Airways New Zealand submission to the Civil Aviation Authority's 2017 Taranaki Airspace Review

**Prepared by: John Wagtendonk
Policy, Standards and Safety Improvement**

Updated version 4 25 March 2017

DRAFT New Plymouth CTR Proposal

Diagram 1 Draft NP CTR

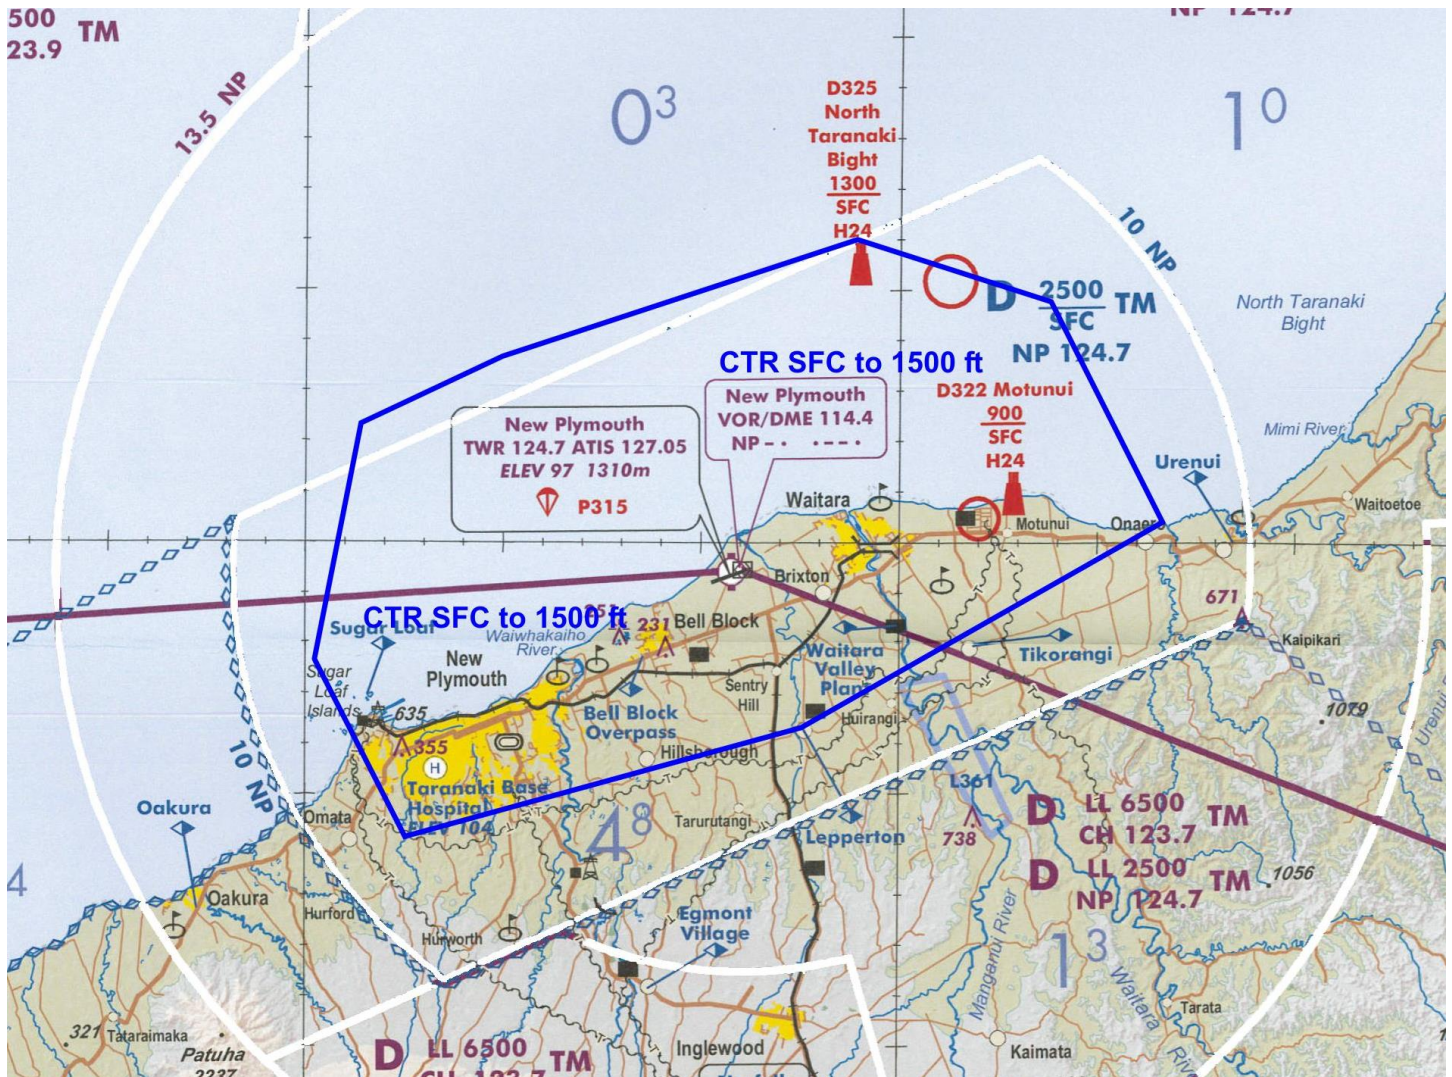
A primary reason for reducing the size of the NP CTR is to reclassify as Class G the airspace that is not currently needed for air traffic control purposes or for containment of instrument flight procedures.

1. The upper limit of the CTR is lowered from existing 2500 ft to 1500 ft.
2. The CTR boundaries are designed to contain the existing VOR/DME approaches based on the aircraft flying a continuous descent profile, including during the base turn, of not shallower than 300 ft per NM to runway threshold/elevation. This is based on AIPNZ ENR 1.5 – 2 para 1.3.3
3. The expanded northern boundary of the draft CTR contains the right-turning VOR/DME RWY 23 missed approach track based on a 300 ft per NM gradient from the VOR at 450 ft MDA. This is based on AIPNZ ENR 1.5 – 2 para 1.3.9. A 2.5 NM buffer from the nominal missed approach track is applied.

4. The CTR provides containment for Cat A and B circling. In accordance with airspace design policy, containment of Cat C circling is not necessary as straight-in approaches are available. However, for other design reasons, the Cat C circling area to the north of NP is contained (but not to the south). If this draft CTR does get designated **then an appropriate notation should be made on approach charts regarding lack of Cat C circling protection to the south of New Plymouth.**

5. As well as new PBN straight ahead SIDs, the draft CTR provides for containment of PBN SIDs that turn north/seaward by 30 degrees after take off. A 2 NM buffer is provided between the draft CTR boundary and the nominal track of the RNAV departures to the point where the departure passes 2,000 ft climbing at 300 ft per NM.

6. The draft CTR provides for containment of departures utilising the evaluated climb sector chart (AIPNZ NZNP AD 2 – 62.1) **provided that the chart/departure is amended to specify “minimum turn altitude 1100 ft”** (Current requirement is minimum turn altitude 500 ft)

7. Airspace containment for the NP VOR RWY 05 and NP VOR RWY 23 approaches (the non-DME approaches) is not assured. Most of the approach would be within the draft CTR and CTA but portions of the approach may not be depending on how far outbound the aircraft tracks. **It is suggested that the approaches are annotated along the lines of “Airspace containment not assured for base turn.”**

Diagram 2 Draft NP CTA version 3

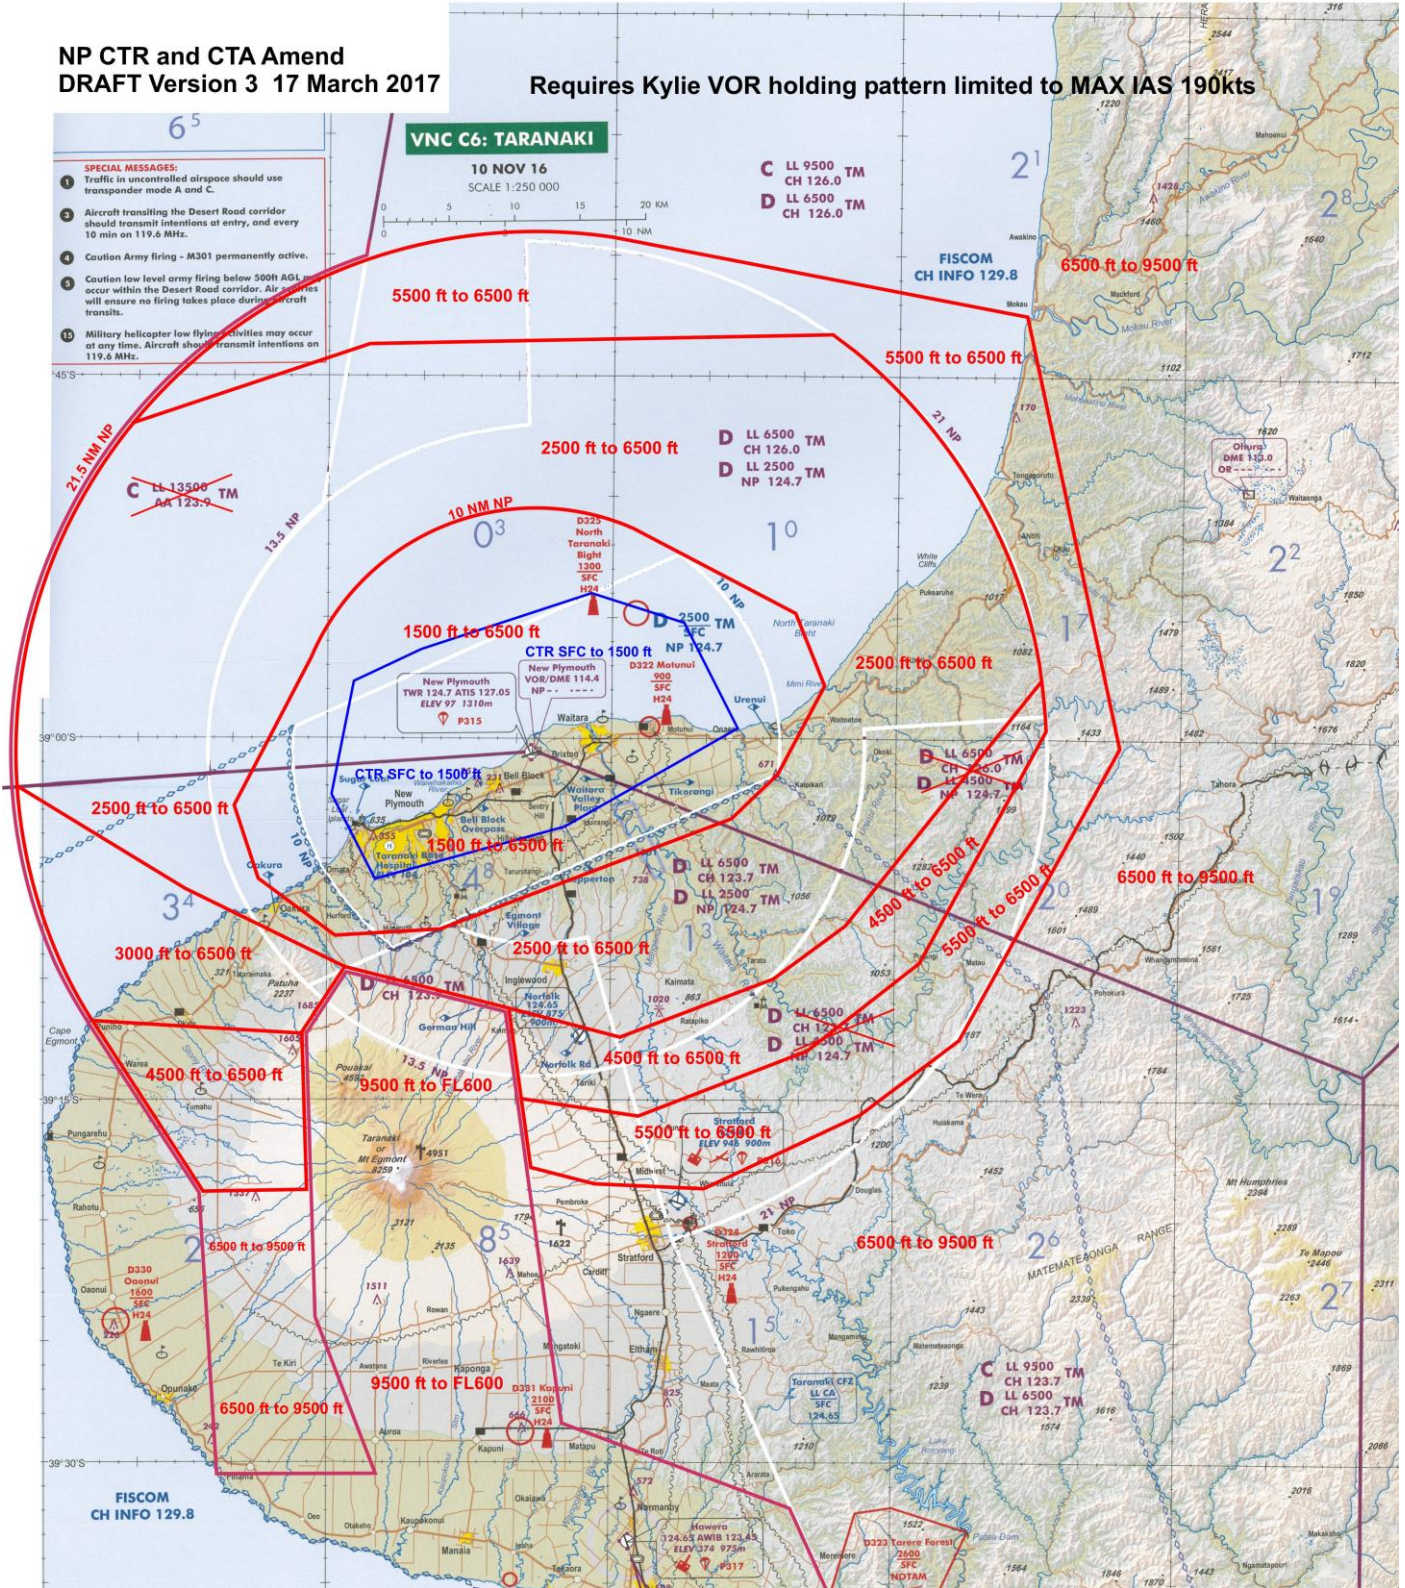
1. The CTA boundaries are designed to contain the planned new NP PBN SIDs and STARs that are being developed. A minimum of 2 NM buffer between the nominal track of the SID/STAR and the CTA boundary is applied. The CTA steps are based on a continuous 300 ft per NM climb/descent gradient from RWY threshold and elevation – except that the 5500 ft to 6500 ft CTA just north of Stratford is based on the 6000 ft altitude restriction in place on IFR departures through new waypoint EGMON.

2. The CTA is minimised as much as practical to fit around the PBN SIDs and STARs and this does lead to the ‘strange’ shapes of the various CTA portions. Where felt appropriate, the CTA boundaries have been moved out a little to nearby geographical features but in many places there is no obvious feature available unless significantly adding to the CTA. Airways welcomes any input from operators as to how the boundaries could be made more ‘user friendly’ whilst still providing the required containment of the IFR procedures.

3. Lowering the upper limit of the CTR to 1500 ft results in the need to add the new CTA portion around NZNP with LL 1500 ft.
4. The extensive CTA LL 2500 ft is needed to provide containment of the holding patterns down to 3000 ft at *ILAND* (new PBN waypoint), *MIMIR* (new PBN waypoint) and *KYLIE* (*see note below*) as well as the two holding patterns for the NP VOR. The *SUGAR* (new PBN waypoint) hold is contained down to 4000 ft. (It is intended that descent below 4000 ft would be permitted once established inbound to SUGAR to leave the holding pattern.)

Note: For containment in this draft CTA the KYLIE holding pattern needs to be limited to MAX IAS 190 kts.

5. The CTA LL 2500 ft is expanded to the south of NZNP closer to the mountain to contain the PBN arrivals to RWY 05 and the departures from RWY 23. Refer diagrams 3 and 4.
6. The added CTA LL 3000 ft, LL 4500 ft and LL 6500 ft to the west of the mountain is needed to contain the PBN arrivals and departures that track around the west of the mountain. Refer diagrams 4 and 5.
7. As previously mentioned, the Auckland CTA LL 6500 ft and the Christchurch CTA LL 6500 ft both need to be expanded westward of NZNP to match the expanded CTA below. The CTAs above will also need boundary changes to match (NZA147 AA CTA/C 9500 ft to FL600 and NZA149 AA CTA/C 13500 ft to FL600)
8. The IFR arrival and departures via MANGA to the south of NZNP are not contained outside 16 NM at 5000 ft as these tracks are used by operators intending to go outside controlled airspace to Hawera.

9. The draft control zone will contain departures using the evaluated climb sectors chart (with minimum turn 1100 ft), however, the draft CTA is not designed to fully contain departures on all 360 radials.

The draft CTA is designed to provide full containment of the VOR radials approximately 340 out to 30 NM clockwise to 150. Radials west of those may not be contained depending on distance and climb gradient. *(Note: some further work would need to be done to determine exactly which radials would be contained.)*

The existing South Three departure will not be contained by the draft NP CTA **therefore this departure either needs to be withdrawn or, if it is desired to be retained, annotated as not being contained by controlled airspace.**

10. Airways does have some concern about the added complexity of the added 5500 ft CTA step but will leave it to CAA and interested parties to consider. If it is considered to be too complex or not practical, the 5500 ft CTA step could be lowered back to 4500 ft.

Diagram 3 Draft PBN STARs to RWY 05 and Draft NP CTA

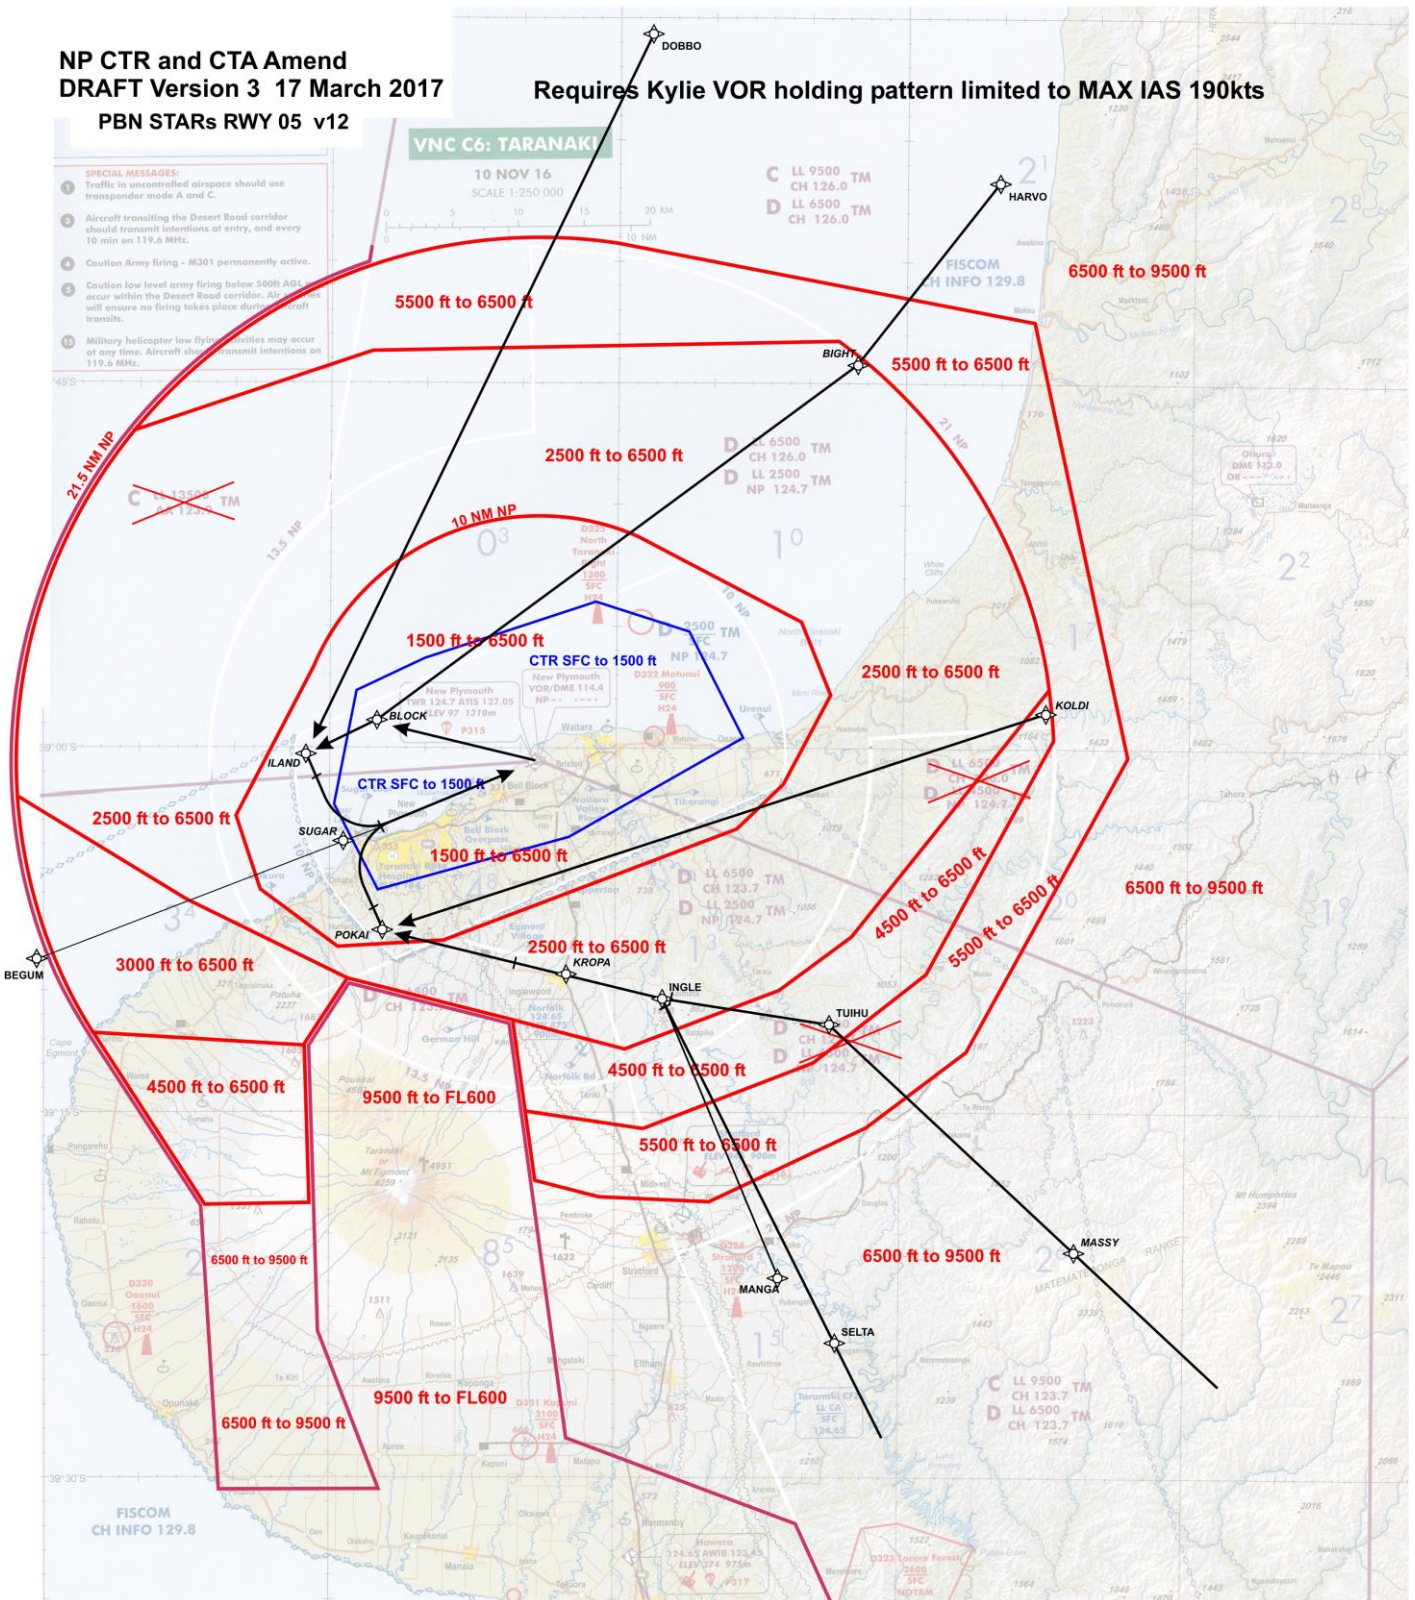
Requires Kylie VOR holding pattern limited to MAX IAS 190kts

Expanded AA and CH CTAs above 6500 ft

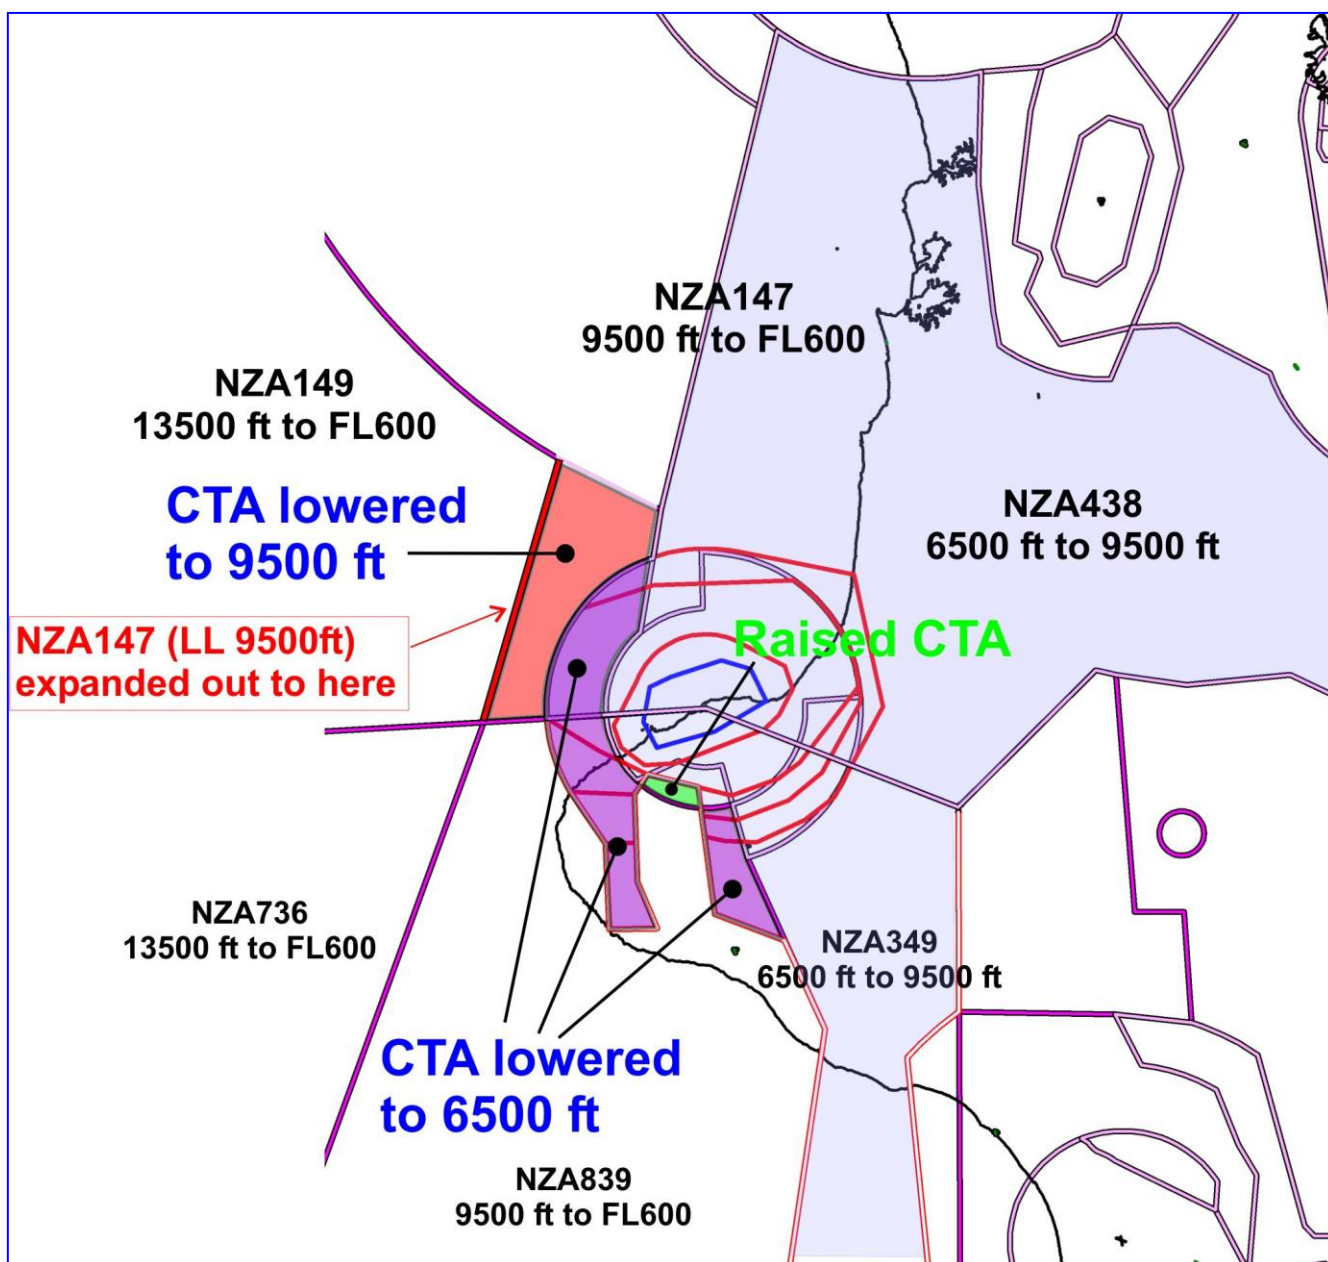
Expanding the NP CTA (up to 6500 ft) to the west and southwest requires that the overlying AA and CH CTAs are also expanded to match as depicted in the diagram below. Those CTAs are;

NZA438 AA CTA/D 6500 ft to 9500 ft; NZA349 CH CTA/D 6500 ft to 9500 ft;
NZA147 AA CTA/C 9500 ft to FL600; NZA149 AA CTA/C 13500 ft to FL600

Additionally, we request a portion of NZA149 is lowered from 13500 ft to 9500 ft. That lowered portion of CTA would be incorporated with NZA147 which has a lower limit of 9500 ft. Effectively, the NZA147 boundary is moved westward by around 15 NM. The new NZA147/NZA149 boundary matches the boundary of the Raglan ATC Sector. It also results in the CTA in the Raglan ATC Sector in that area being a consistent 9500 ft lower limit.

NOTE: The Raglan ATC Sector, currently based in the Christchurch ATC Centre, is going to be relocated to the Auckland ATC Centre. Raglan Sector controls the airspace between New Plymouth and Auckland to the west of Hamilton. The relocation of Raglan Sector may require NZA438, NZA147 and NZA149 to be split into the portions controlled from Auckland and the portions controlled from Christchurch.
